**RULE NOs.: R161-16.21
& R161-16.22**

NOTICE OF RULE ADOPTION

R161-16.22: Revisions to the Standards Manual as follows:

RAIN GARDEN
TYPICAL INLET DETAIL 1

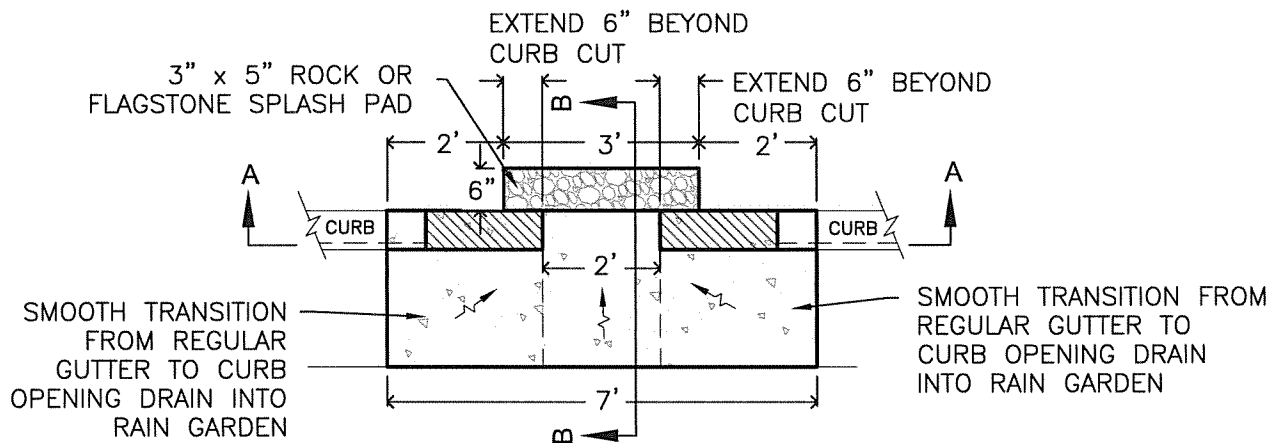
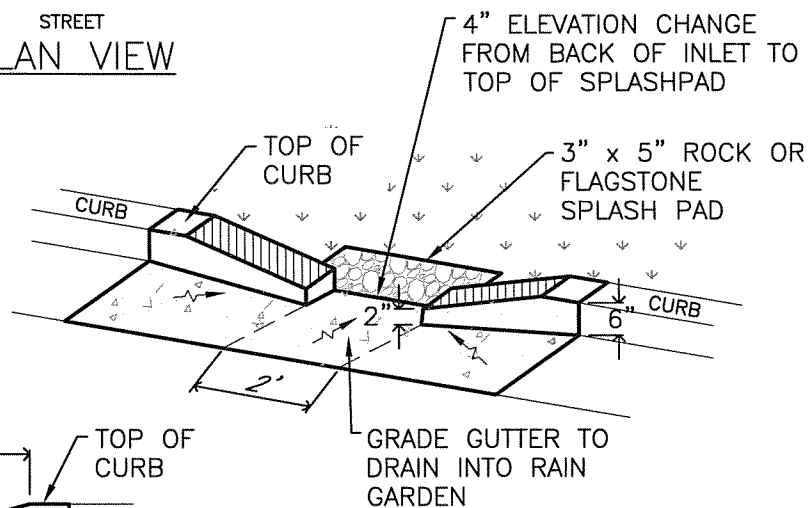
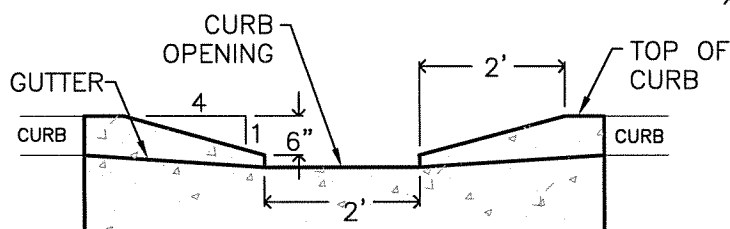
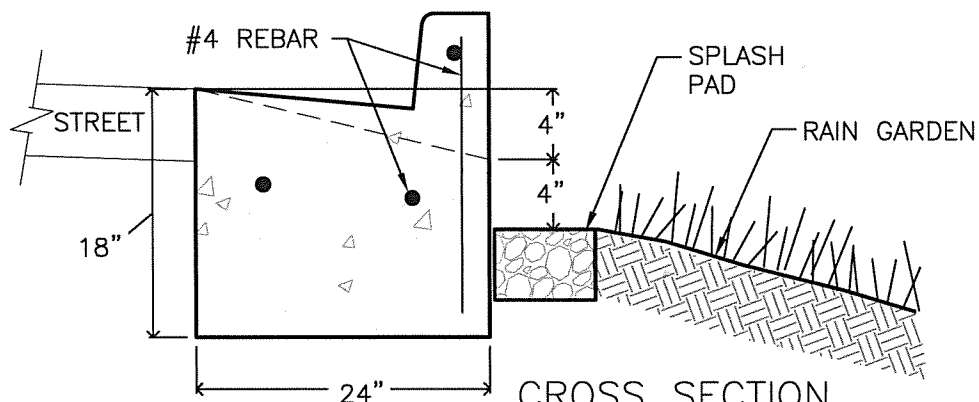
SPD 660-3 and SPD 660-4 – Rain Garden Typical Inlet Details 1 and 2

- Reduced splash pad area and provided dimensions for drop from back of curb to top of splash pad area to improve function and reduce maintenance of rain gardens.

GRADE CONTROL RIFFLE STRUCTURE
WITH EMBEDDED TOE

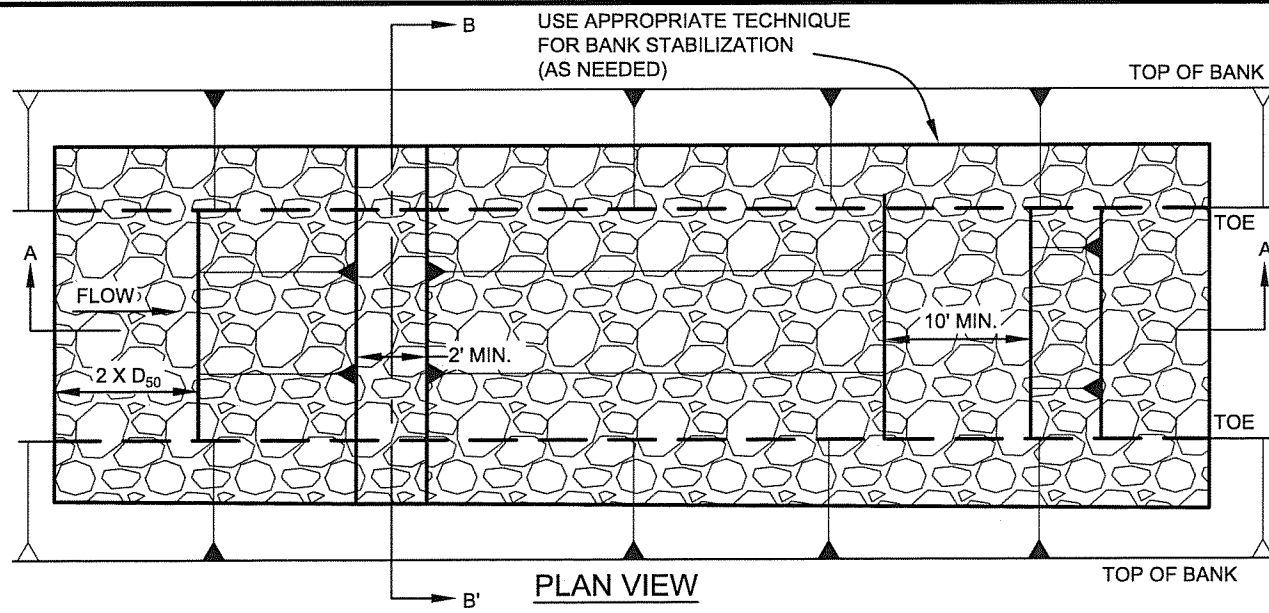
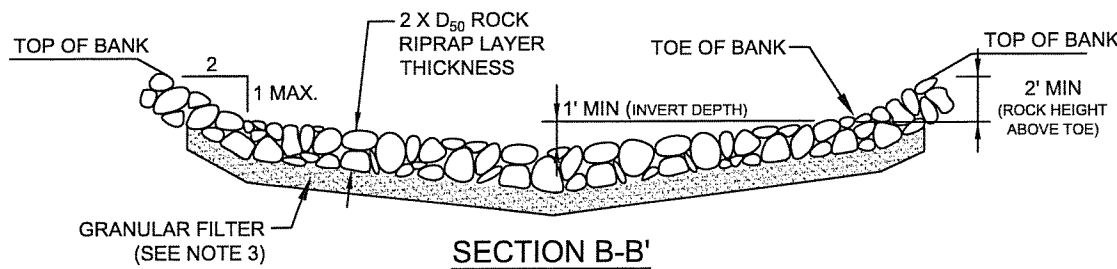
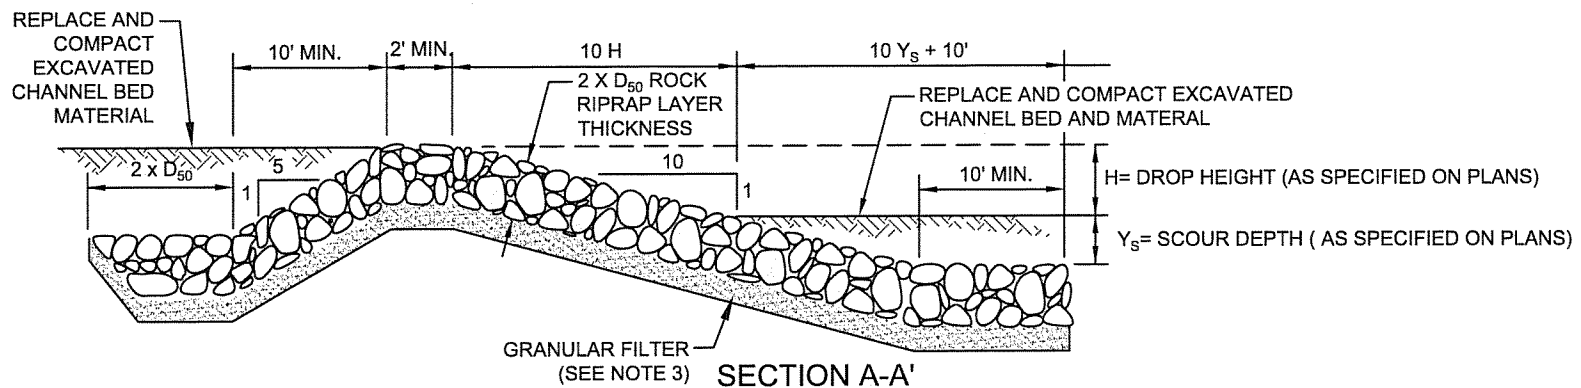
- **625S-2A** – Grade Control Riffle Structure with Embedded Toe
- **625S-2B** – Grade Control Structure Rock Riffle with Preformed Scour Pool
- **625S-3A** - Grade Control Structure Rock Riffle with Concrete Crest and Embedded Toe
- **625S-3B** - Grade Control Structure Rock Riffle with Concrete Crest and Preformed Scour Pool
- **625S-4A** - Grade Control Structure Rock Riffle with Boulder Crest and Embedded Toe
- **625S-4B** - Grade Control Structure Rock Riffle with Boulder Crest and Preformed Scour Pool
- **625S-5A** - Grade Control Structure Rock Riffle with Wastewater Crossing and Embedded Toe
- **625S-5B** - Grade Control Structure Rock Riffle with Wastewater Crossing with Preformed Scour Pool
- **625S-6** – Straight Stepped Rock Drop
